**City of Santa Barbara
Community Development**

Memorandum

DATE: November 16, 2015
TO: Building & Fire Code Appeals Board
FROM: Andrew Stuffer, Chief Building Official *AS*
SUBJECT: Bradley Studios Managers Office 2nd Door

RE: **Bradley Studios Manager Office**

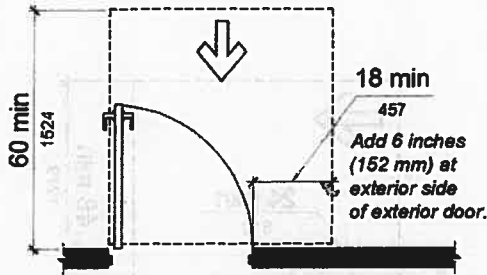
The proposed 2nd door leads from a small manager's office which discharges to an interior stair landing that serves both an exterior door and the interior stairs serving manager's dwelling unit above. The required 2013, California Building Code, Chapter 11 landing and door approach areas for the proposed 2nd door cannot be accommodated at the interior stair landing side of the proposed door without extensive re-framing of an office as well as the interior stairway and stair landing serving the manager's dwelling unit on the second floor. Please refer to Attachment 2 for California Building Code graphics on minimum door landing and door approach requirements.

I would like to request that the City approve the installation of the second door as an emergency exit. The door would be used for the expressed purpose of emergency exit door and would be labeled as such. The location of the proposed door is shown on the attachment.
